STAFF REPORT FOR THE CITY COUNCIL

FILE NO: AP-12-01

REQUEST: Appeal by the Savanna Oaks Neighborhood Association of the Planning Commission's approval of a Conditional Use Permit and Class II Design Review for a proposed water pump station at the Bland Reservoir Site, 23120 Bland Circle (CUP-12-01/DR-12-03).

PREPARED FOR:
CITY OF WEST LINN

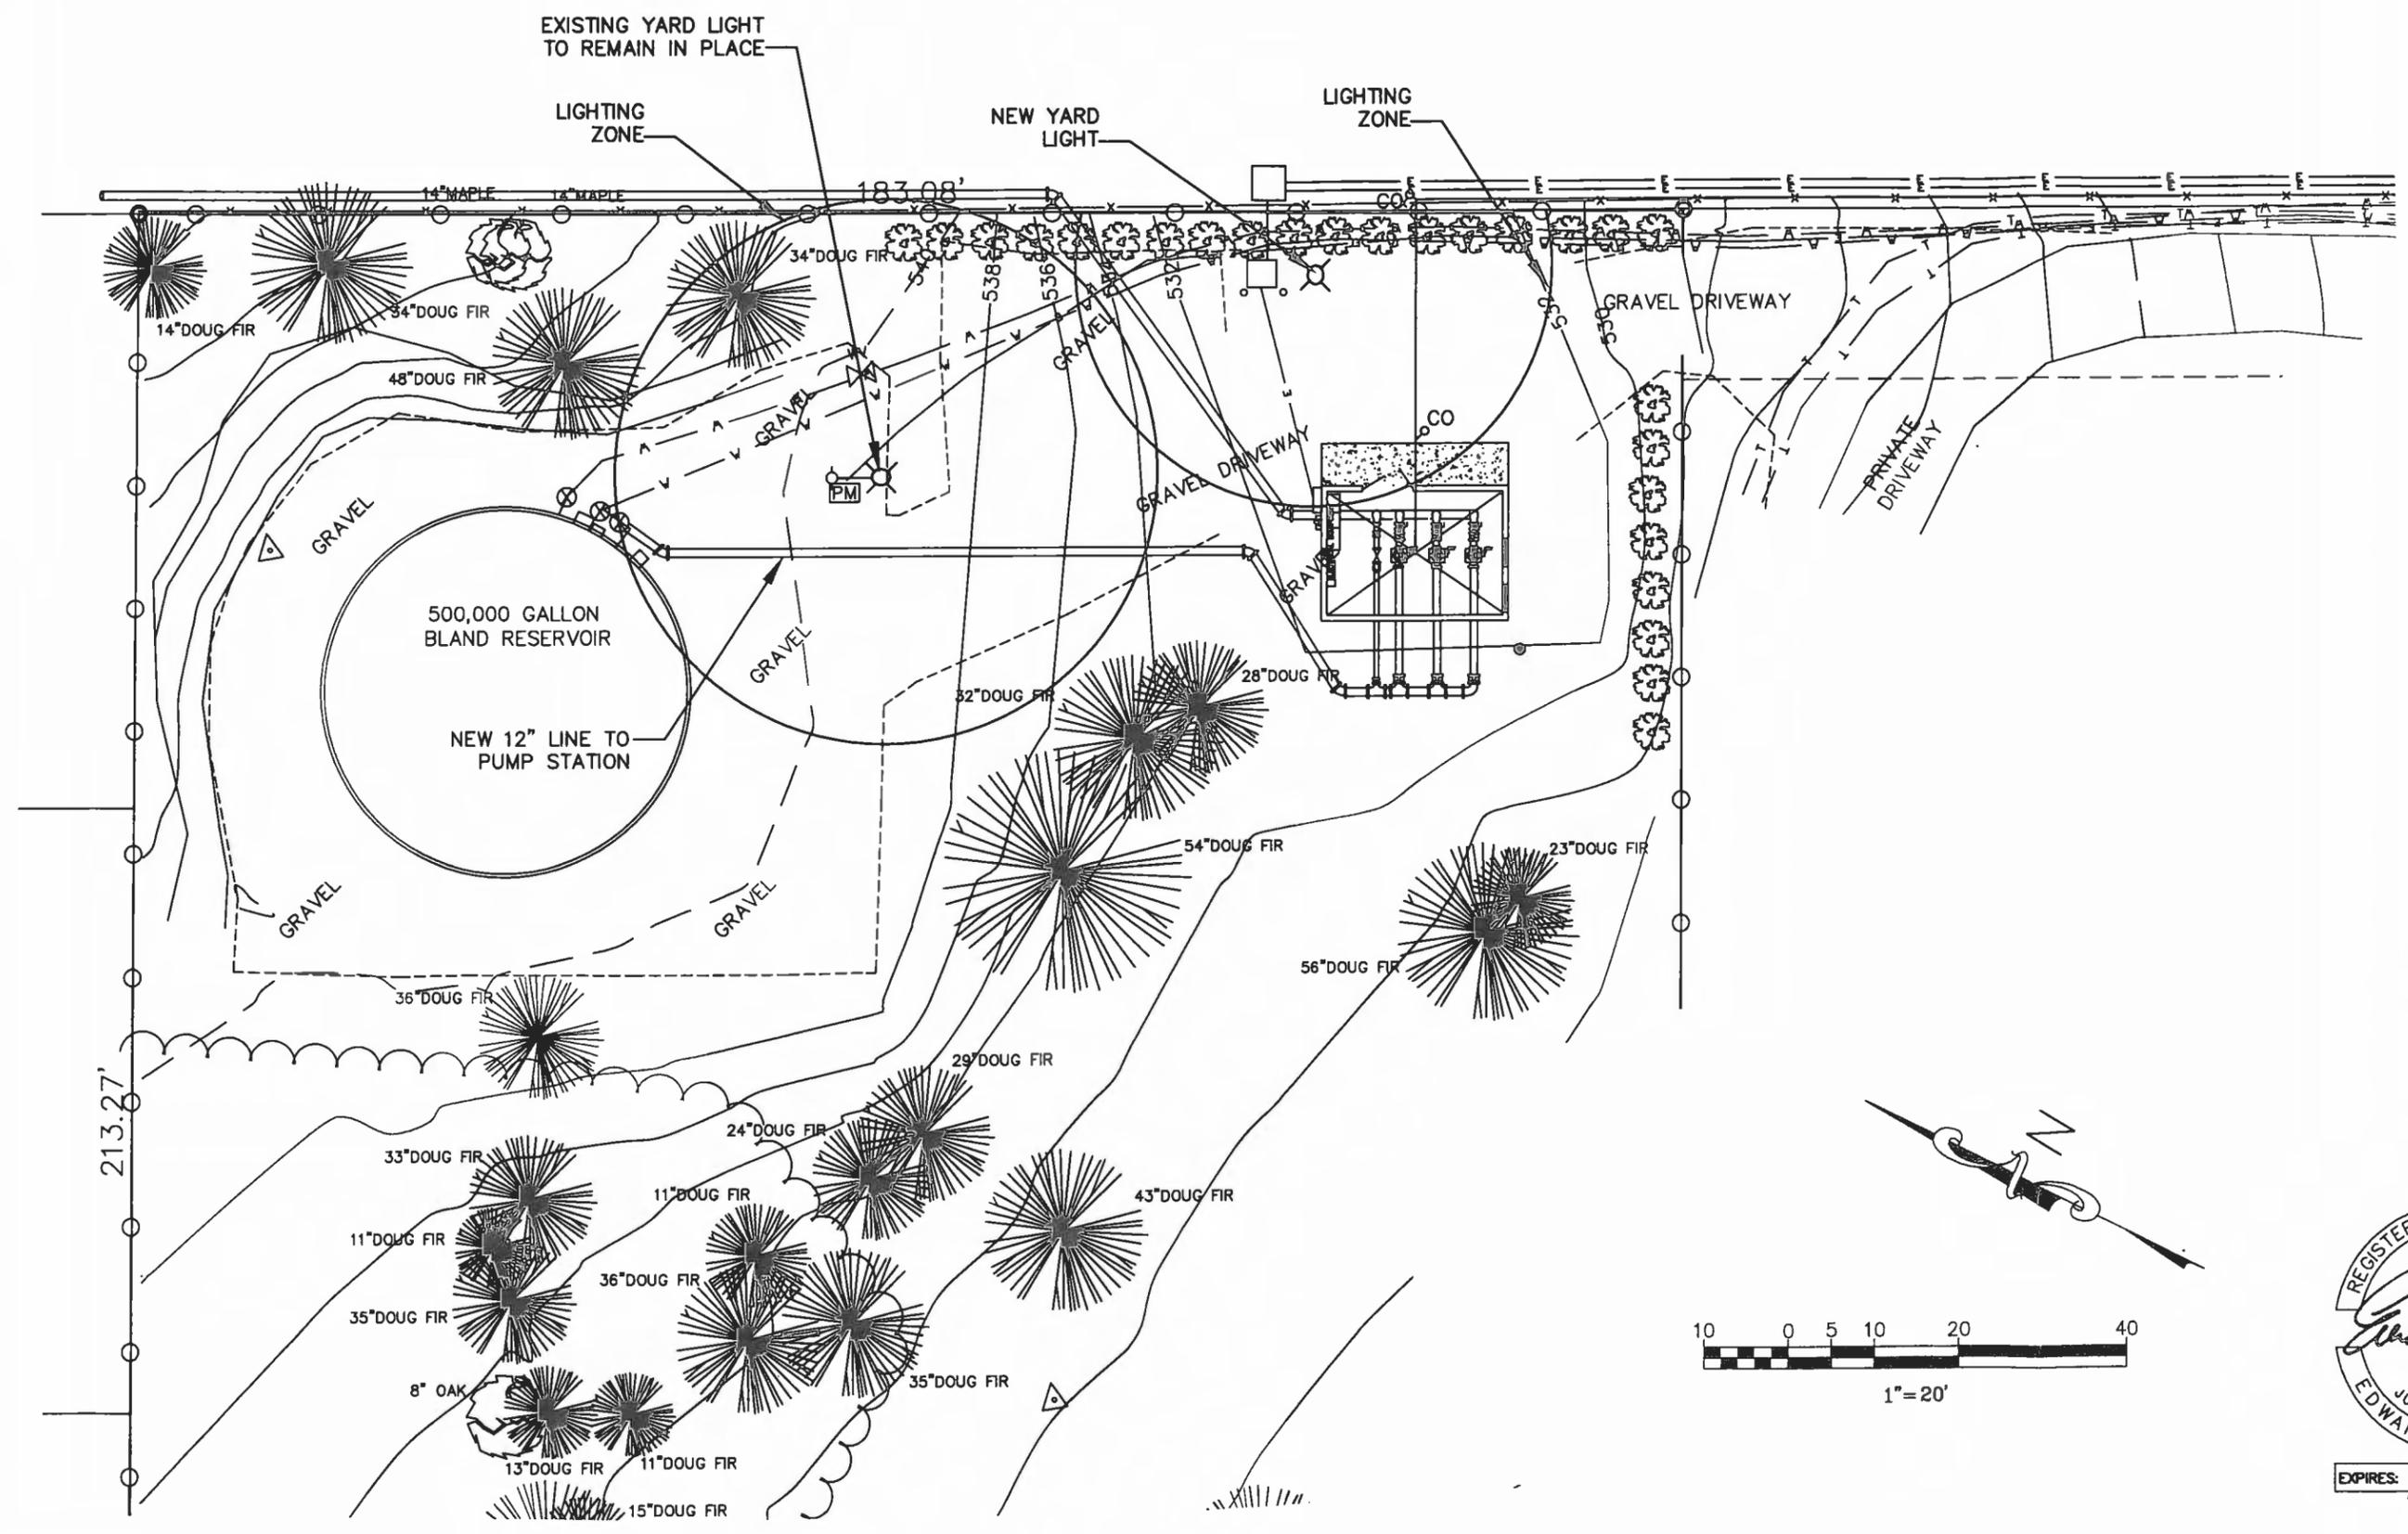
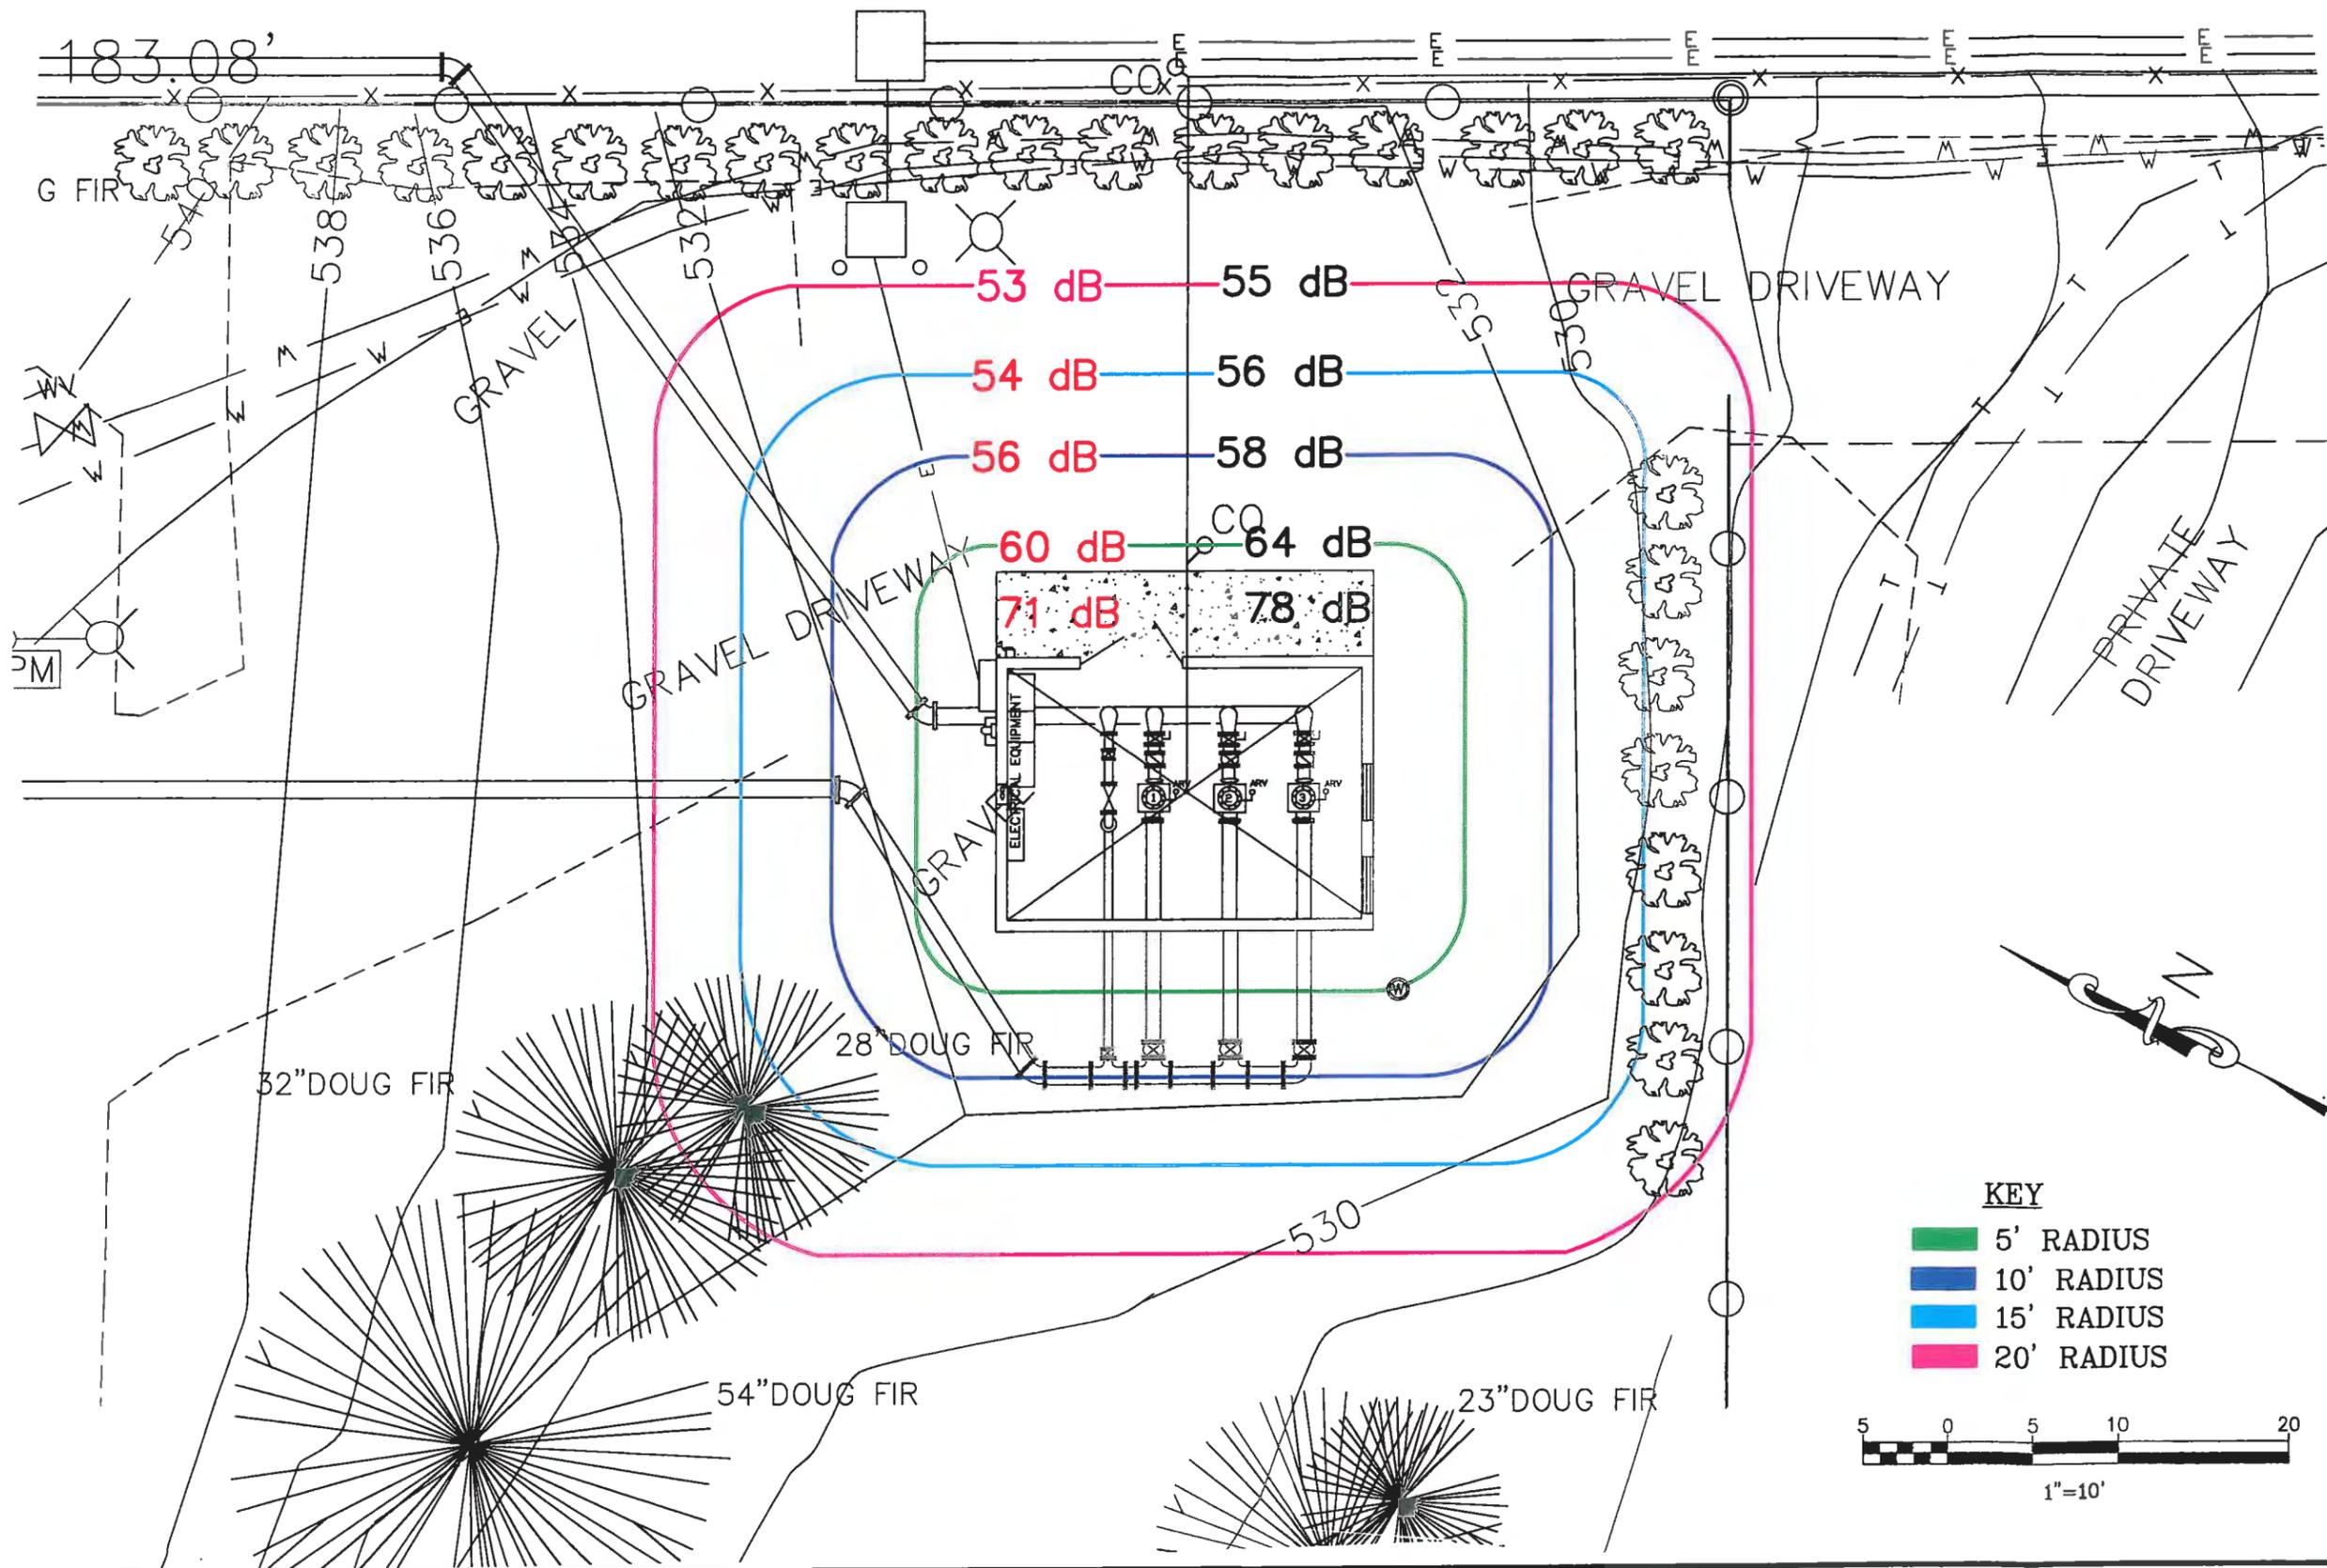
The Sound Levels plan on Page 277 of Exhibit CC-7 shows that the station will not cause ambient noise to change off site except possibly the rearmost 1-2 feet of the site to the south, which does not reach the existing house on that site and which is within the areas where setbacks would prevent development if that site was ever annexed to the City. The required screening of the proposed pump station, the existing trees, and the existing reservoir structure will further mitigate impacts on surrounding properties. The proposed fencing will keep children out of the site and thereby prevent them from potential on-site dangers. In their letter on Pages 258-259 of Exhibit CC-7, Tualatin Valley Fire and Rescue (TVFR) stated that the existing driveway width is sufficient for them to serve the site. Possible risks associated with a water release in the event of a major earthquake are discussed in item 6 below.

The Sound Levels plan on Page 122 of Exhibit PC-3 shows that the pump station will not cause ambient noise to change off site except possible the rearmost 2 feet of the site to the south, which does not reach the existing house on that site and which is within the areas where setbacks would prevent development if that site was ever annexed to the City. The proposed arborvitae screening on the east and south of the proposed pump station, existing trees, and the existing reservoir structure will somewhat mitigate impacts on surrounding properties. There is no language in either the CDC or the West Linn Municipal Code prohibiting the level of noise off-site that would result from this proposal.
